RE: Nine Mile Point Unit #1  
Docket No. 50-220

Amdt to OL/Change to Appendix B Tech Specs:  
Revising Appendix B in it's entirety by the  
submittal of attachment A & B which cover  
the following areas:

It is proposed that the Environmental Technical Specifications for Nine Mile Point Unit 1 be revised in four general areas:

FIGURE 5.3  
SAFETY ORGANIZATION  
NINE MILE POINT - JAMES A. FITZPATRICK SITE

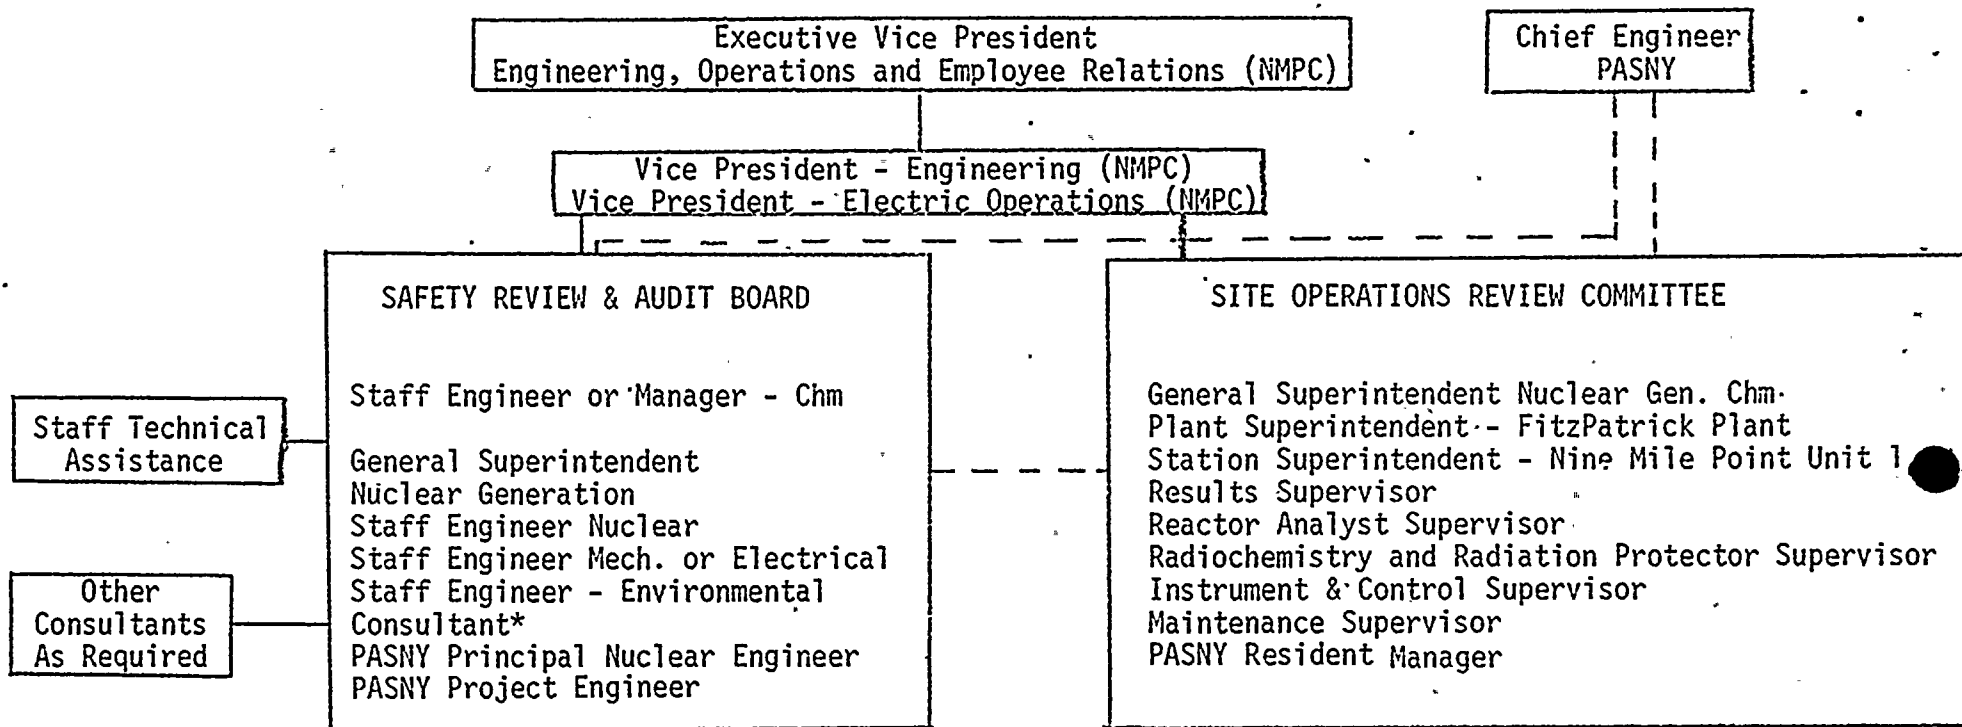
5.1	Changes in words to conform to Appendix A.	Editorial
Figure 5.3	Modification in SRAB to include PASNY Project Engineer. Change title of PASNY representative to SORC to correct title.	Editorial
